Delegated Report

Householder Planning Application

Planning Application No: 20221006

Description: Alterations to existing driveway to create an additional entrance/exit with a second vehicular access.

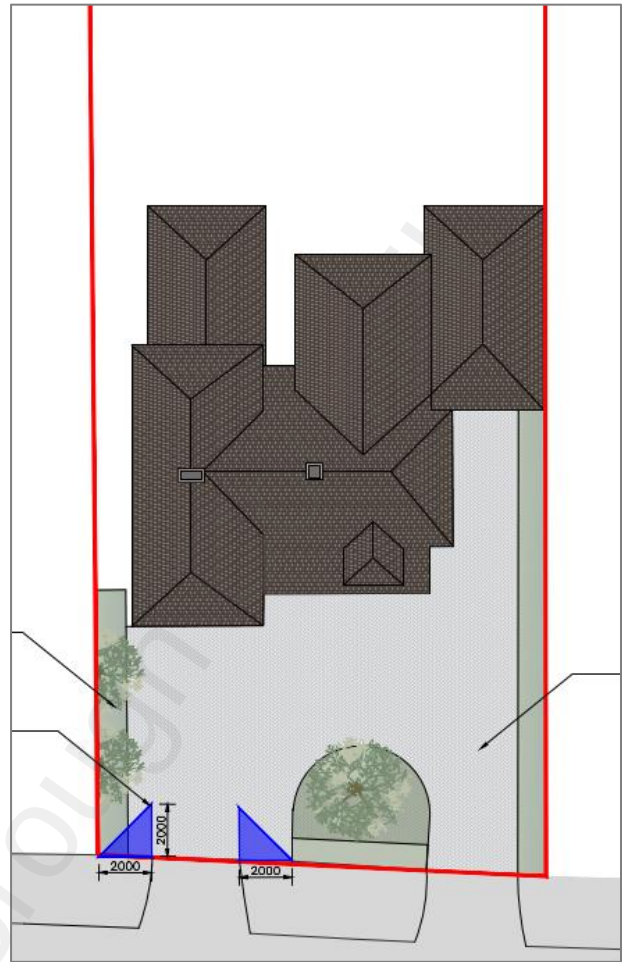
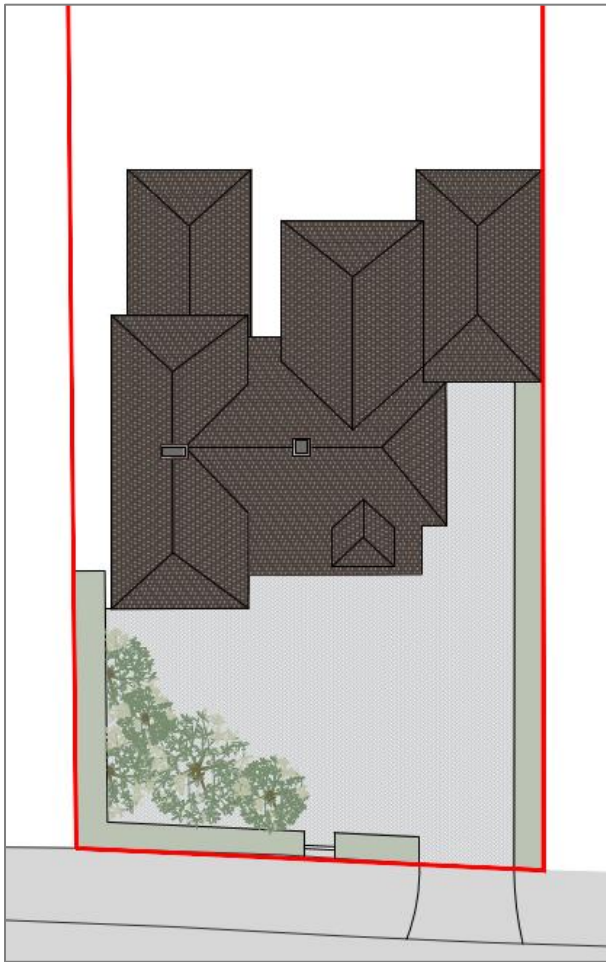
On the originally submitted plan for the site landscaping, gates were shown on the two driveway entrances, though these were not shown on the submitted elevations, nor mentioned on the application form.

Due to highway concerns about gates and lack of pedestrian visibility splays, the agent has submitted a revised site landscaping plan which removes the gates and adds visibility splays. No change to the description was necessary for these minor changes.

The proposal would reduce the amount of landscaping at the front of the site, as shown below:

The proposal involves removing a section of the existing front boundary wall to create a second vehicular entrance (an in-out driveway). The driveway materials will match the existing (block paving). Some additional soft landscaping is proposed behind the central section of retained front boundary wall, and flower beds are retained to both front flank boundaries. 2m by 2m pedestrian visibility splays are shown on either side of the proposed new entrance.

Existing front boundary treatment:

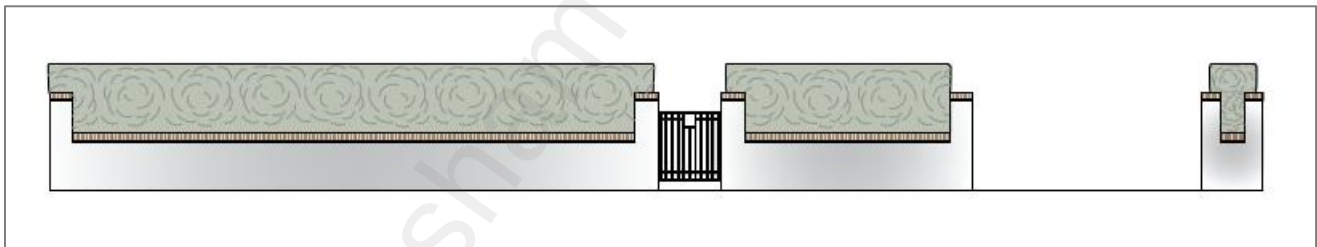
However, the appearance of the front boundary wall is not proposed to be altered, and an area of soft landscaping is proposed behind the retained central section of front boundary wall. In terms of the appearance of the proposed additional access, provided the soft landscaping is carried out as proposed, this would be in keeping with the street scene, and would be an improvement over some of the front driveways on the road that have no soft landscaping. The landscaping can be conditioned to ensure it is carried out. On this basis, the proposal would be considered to be in accordance with Policy CS19 of the
